UNITED STATES PATENT AND TRADEMARK OFFICE

APPLICATION NO.	FILING DATE	FIRST NAMED INVENTOR	ATTORNEY DOCKET NO.	CONFIRMATION NO.
09/602,525	06/13/2000	W. R. Hugh Fife	GECA 3194	8521

Office Action Summary

DETAILED ACTION

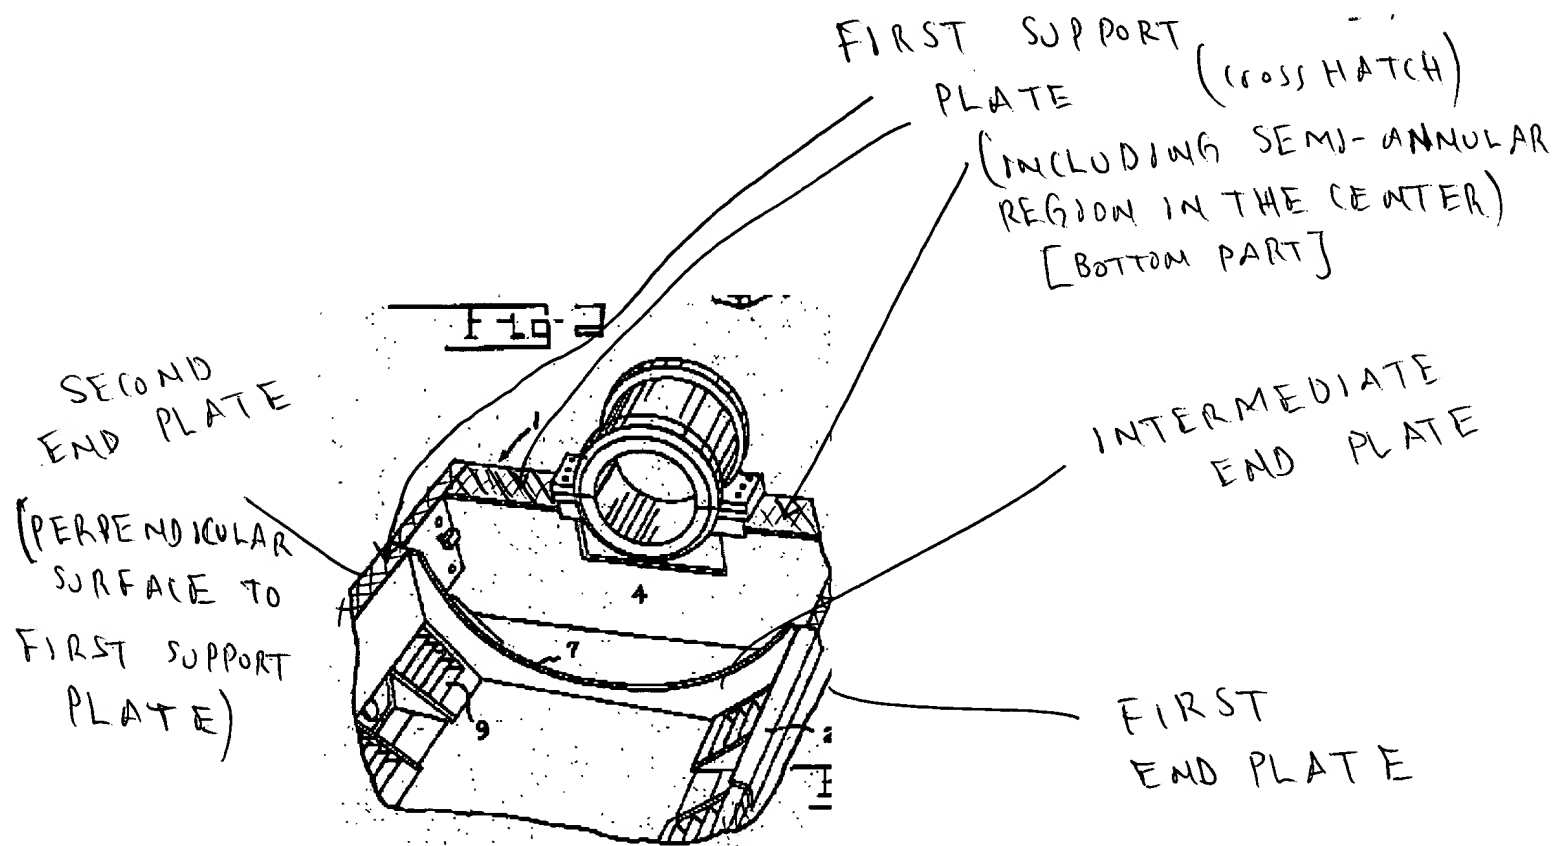
Michel et al discloses a bracket assembly, a stator 10 disposed in the frame, a rotor having shaft 5 within stator 14 (see figure 3), a bearing assembly (see figure 2) for supporting shaft 5 and a bracket assembly having a base (see figure 2), a support member 4, a first end plate and second end plate extending from base, support member 4 extending from base between first and second end plate and the first support plate extending from the first end plate to the second end plate and extending from the support member to a side plate and the support member connected to the first support plate form an enclosure and the side plate extends from the base plate to the first support plate (see illustration of figures 1 & 2 below/next pages).

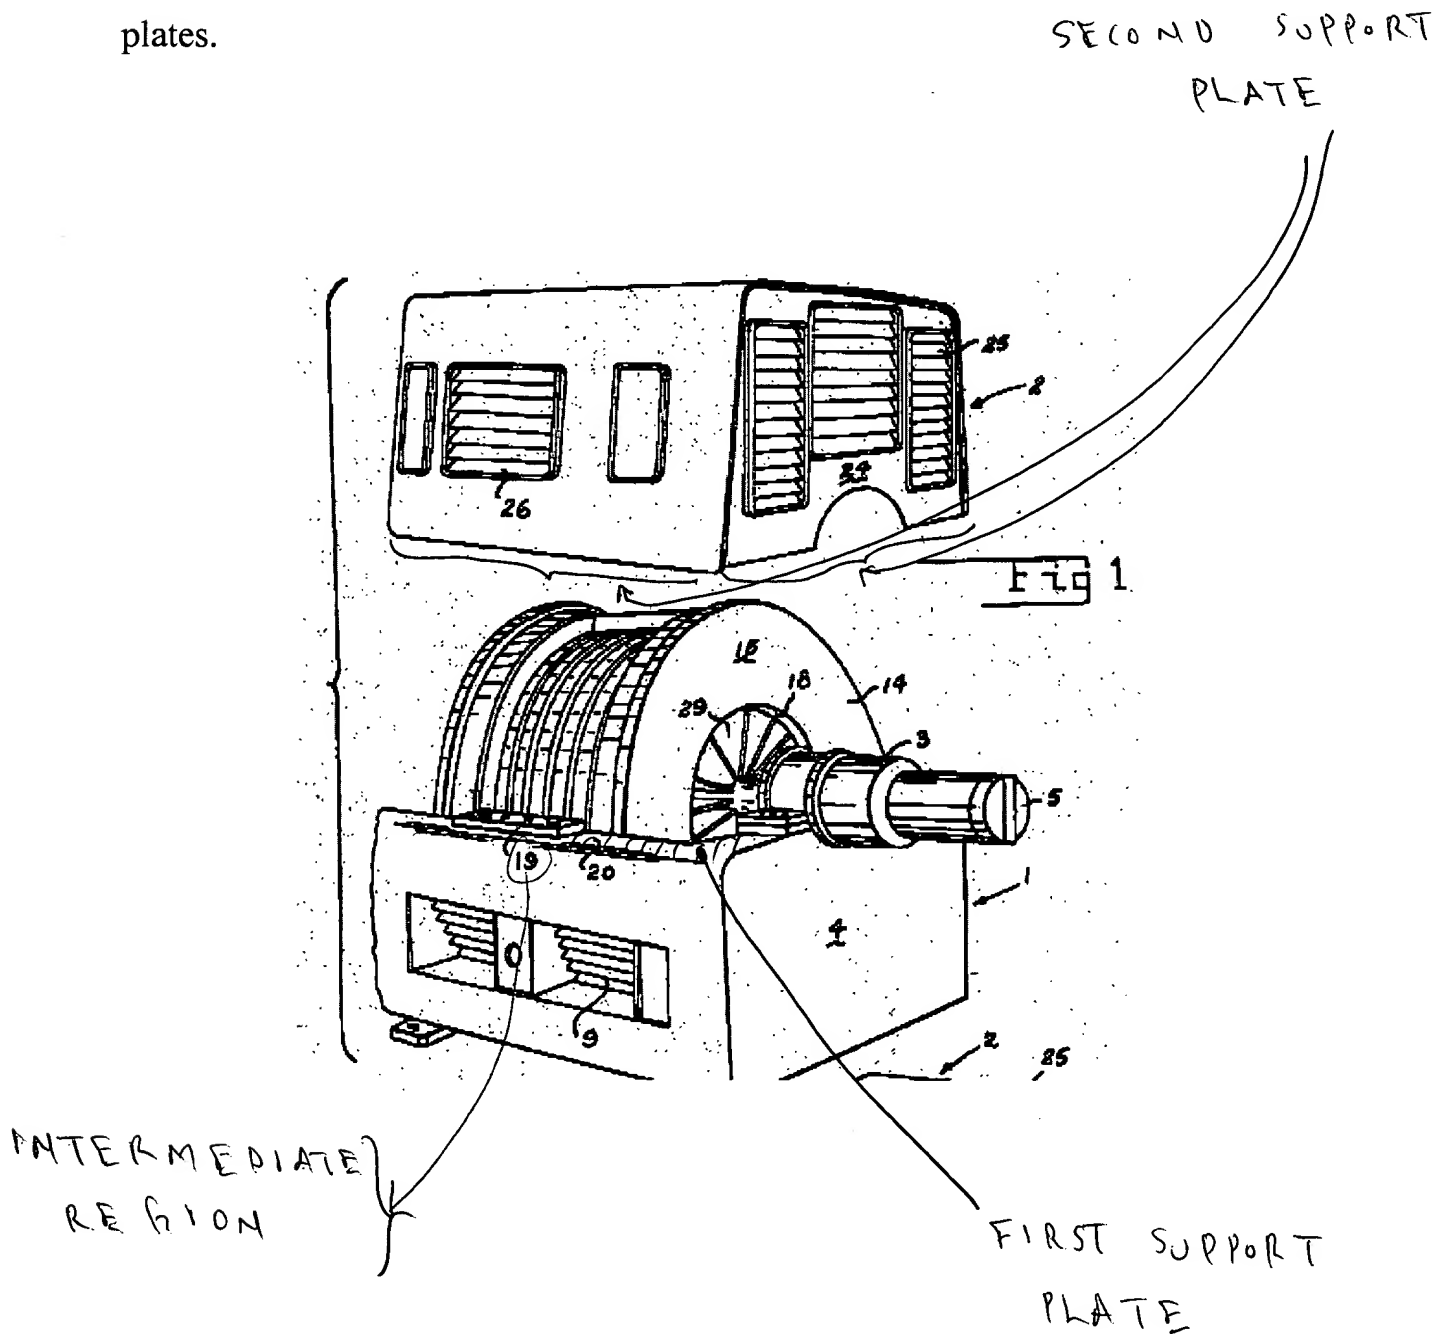
Moreover, Michel et al discloses that the base and first support plate are planar and parallel to each other. Also, an intermediate end plate 7 is disclosed located between first end plate and second end plate (see illustration of figure 2 below).

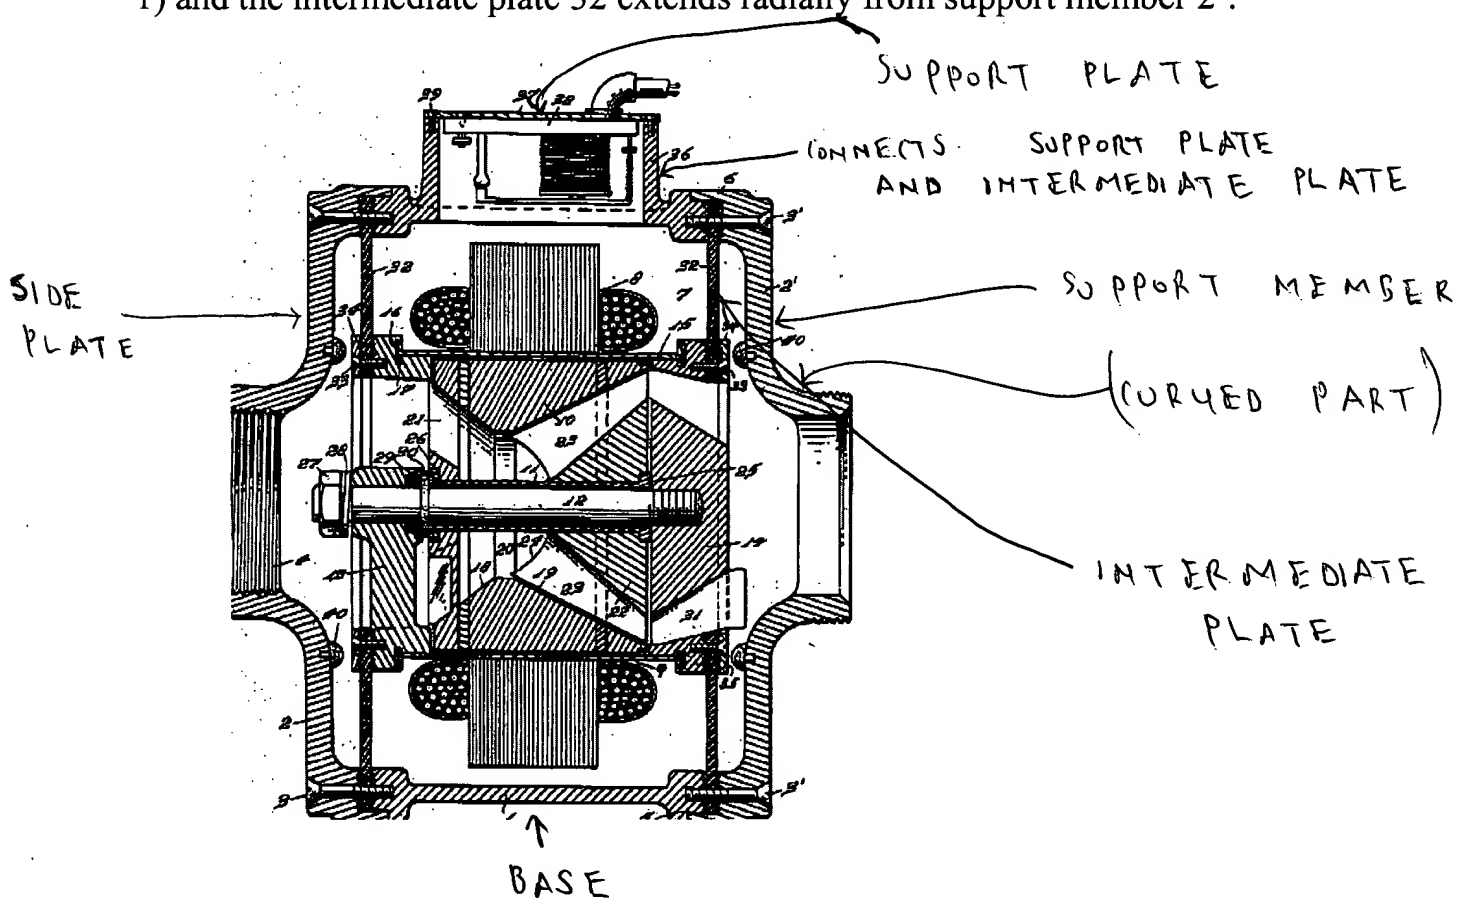
Also, there is disclose a plurality of support plates (bottom and top part of figure 1) and an intermediate region 19 extends between first and second support plates.
